BOARD OF WATER SUPPLY

Subject: Board of Water Supply (BWS) Comments to the Work Plan / Scope of Work, Investigation and Remediation of Releases and Groundwater Protection and Evaluation, Red Hill Bulk Fuel Storage Facility

The BWS and its consultants have reviewed the document titled "Work Plan / Scope of Work, Investigation and Remediation of Releases and Groundwater Protection and Evaluation, Red Hill Bulk Fuel Storage Facility" (WP), dated 4 May 2016, under the Administrative Order on Consent (AOC) Statement of Work (SOW) Sections 6 and 7. Our review of the WP also includes information and statements from the Tuesday 10 May 2016 meeting concerning the AOC scopes of work for AOC SOW Sections 6 and 7. The BWS provides the following comments and recommendations to the WP with the goal of ensuring that all work conducted under the final document will produce defensible scientific and engineering results needed to continue to protect our drinking water supplies from past and future fuel releases from the Red Hill Bulk Fuel Storage Facility (RHBFSS).

Figure 1. Hydrogeologic Scales for Basalt Vadose Zones

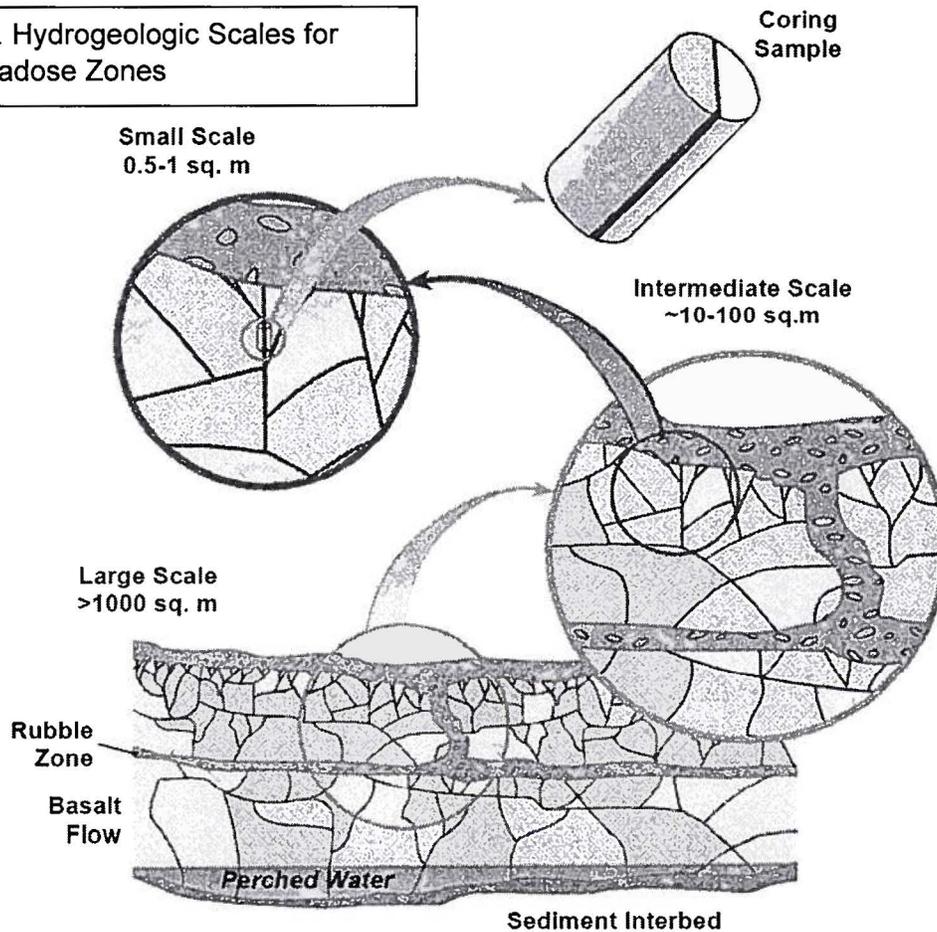
23. Section 3.7.4: Lines 10 through 14 are misleading and should be removed. The statements about low vertical permeability in the basalts presented here and in Sections 3.6.2.3 and 3.7.3 may well be true at small scales on the order of 1 meter², but such statements are readily contradicted by the fact that recharge occurs at rates between 10 and 25 inches per year in the Red Hill vicinity (see Oki, 2005 and Giambelluca 1983 for example). The authors appear to be solely focused on the micro-scale, whereas recharge and contaminant migration occur at the intermediate to large scales (Figure 1 below, which is adapted from Figure 3 in Fabysenko et al., 2000). If the massive components of a'a flows are so impermeable, how can

at Red Hill, why has the Navy invested so much into the system of collection trenches, sumps, and treatment units to handle infiltrating water? If the vertical permeability is so low as to impede vertical flow, why aren't they preventing the fuel contamination from migrating through the vadose zone into the groundwater, causing rising concentrations in vapor below Tank 5 and at monitoring well RHMW02? Relatively rapid migration of infiltrating water through massive basalt flows for small, intermediate, and large scales has been well established elsewhere (Fabysenko et al., 2000; Fabysenko et al., 2001; Baker et al., 2004), and the authors are encouraged to study these reports. As neither water nor fuel appear to have any problem moving vertically through the basalt vadose zone, this text should be revised to account for the large mass flux of water migrating through extensive areas of the basalt vadose zone.
